# ADDENDUM

**Forestside Estates**
Attmar & Palleschi Drive
Brampton, Ontario
Attn: **Vince Staffieri**

**AM 09**

Title: Updated drawings

# GROUND FLOOR OVERALL PLAN

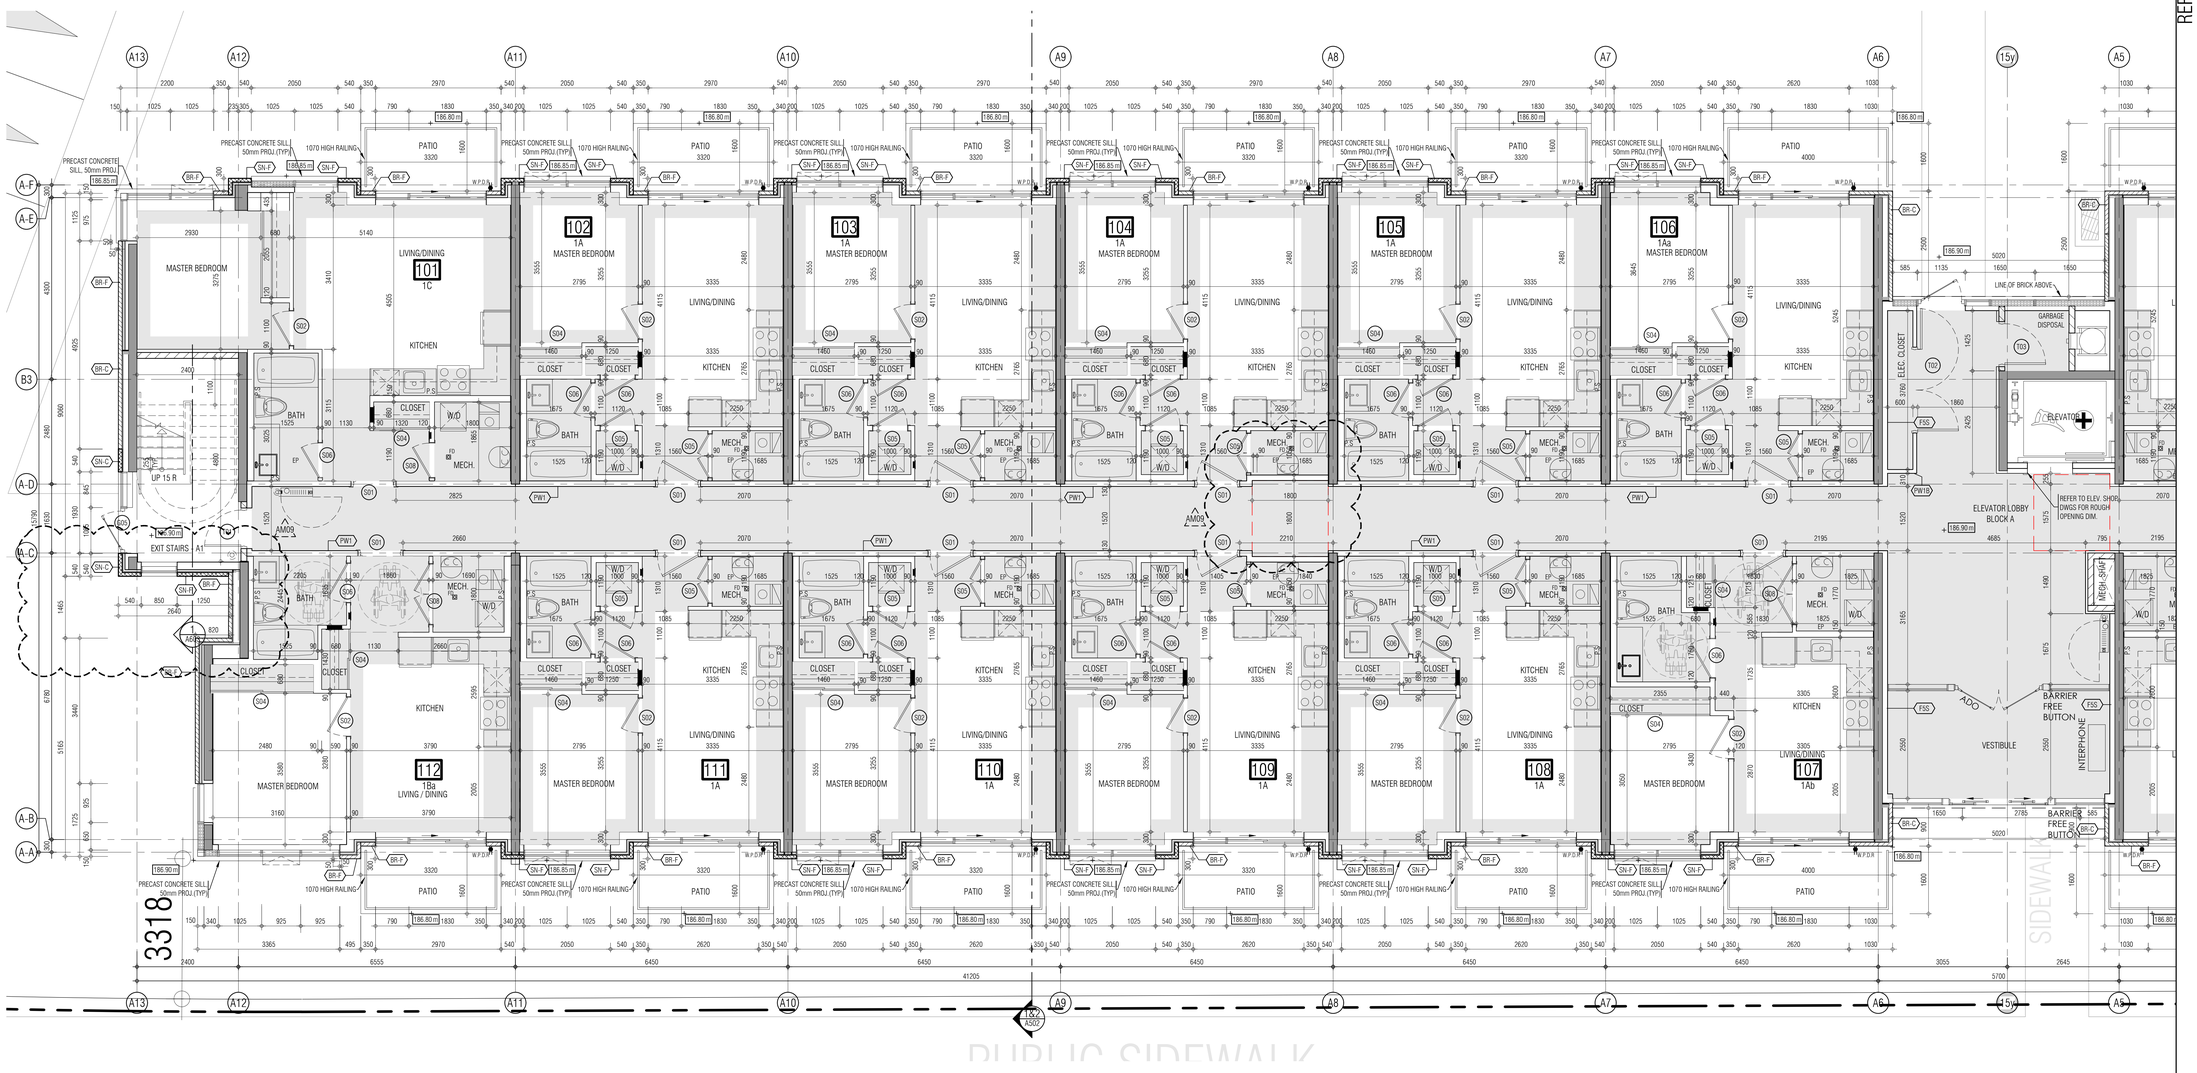
| Reference: | | Changes: |
|---|---|---|
| A301 | 1st Floor Plans | • Revise footprint behind ramp wall. Upstand concrete beam across opening over ramp. Raise Garage roof slab up for ramp clearance. Revise Extent of ramp and indicate additional grades and percentages.<br>• Remove operable window one the side at corner walls where there is an operable in the front. Remove operable windows at corners over exhaust/intake shafts.<br>• Flip Firehose cabinets to opposite wall for corridor space.<br>• Added Wheel chair turn around in corridor in bldg. reducing unit space in mechanical room.<br>• Revised exterior walls at the ends of the cut back area of the block plans to allow for insulation at concrete sheer walls and match dimension on all floor plans. |

BUILDING SECTION 2 / A503
1:50

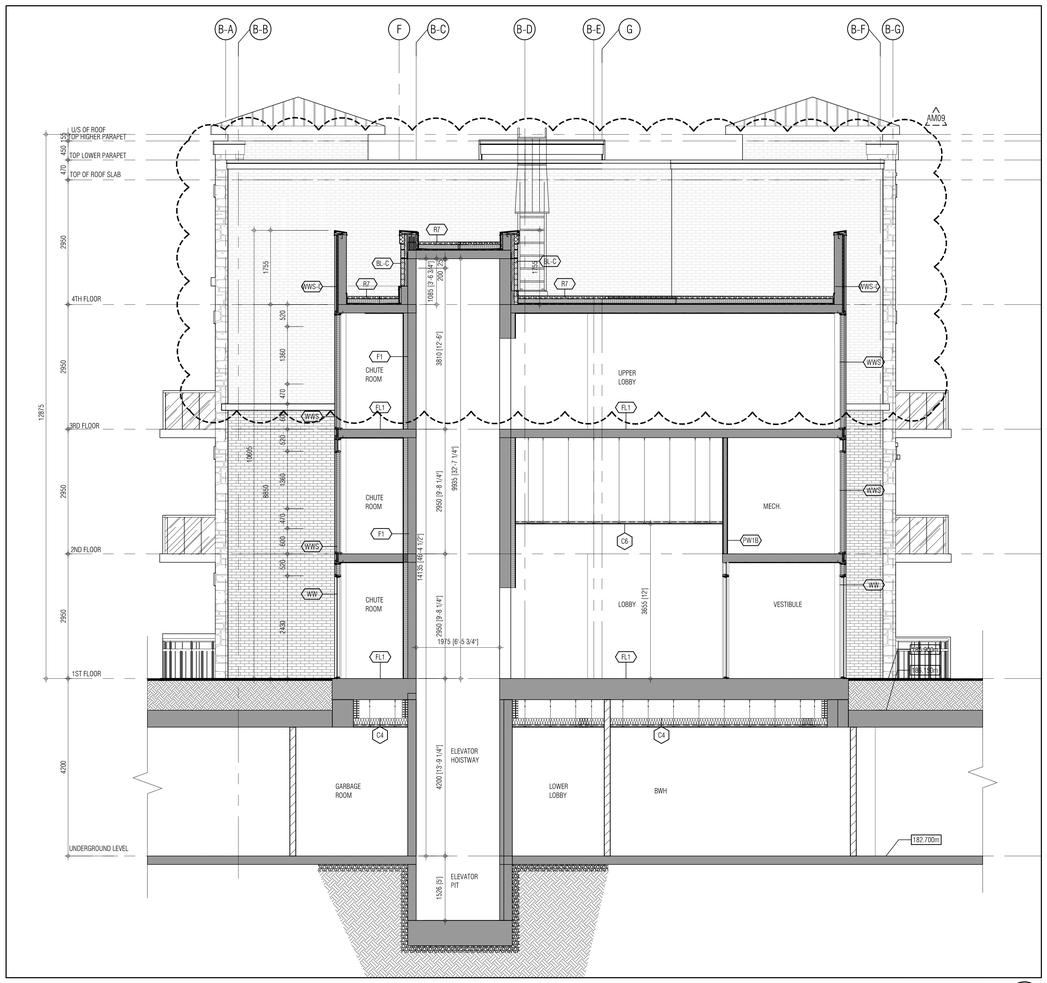
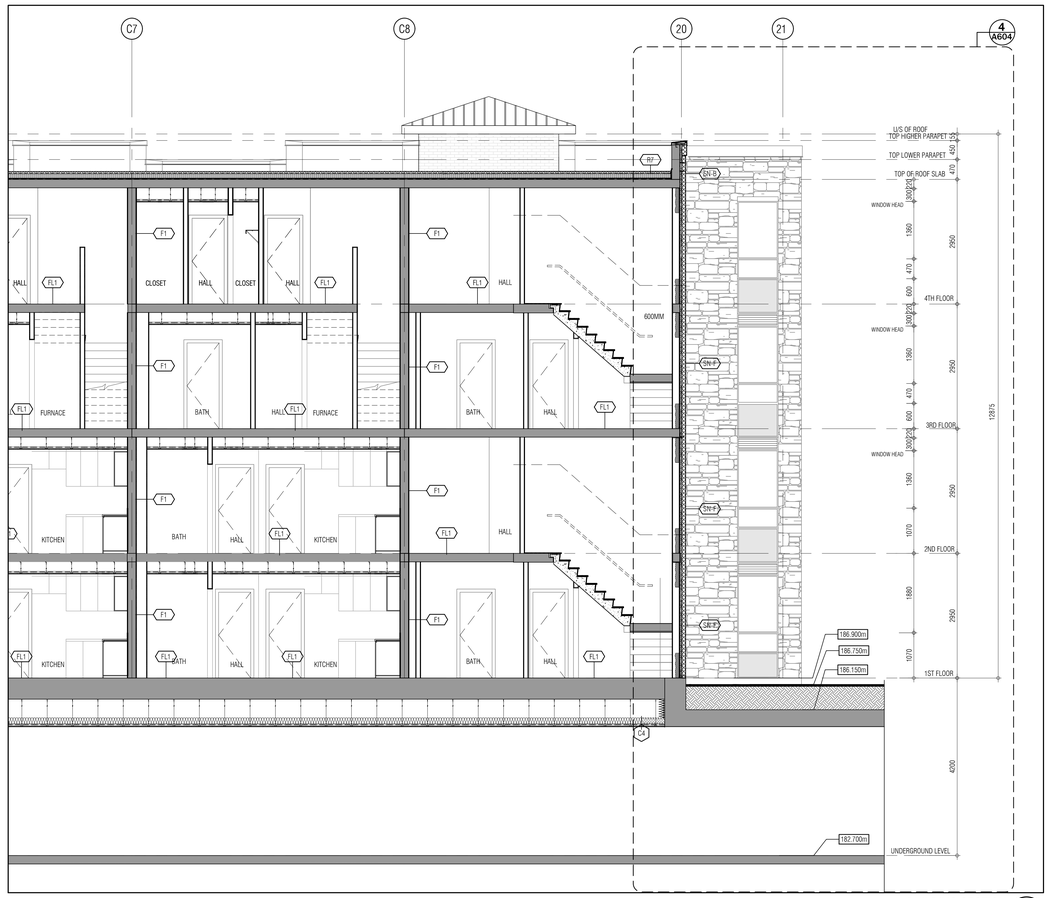
| Reference: | | Changes: |
|---|---|---|
| A503 | Building Section | • Revise link elevation in between buildings to show brick face. |
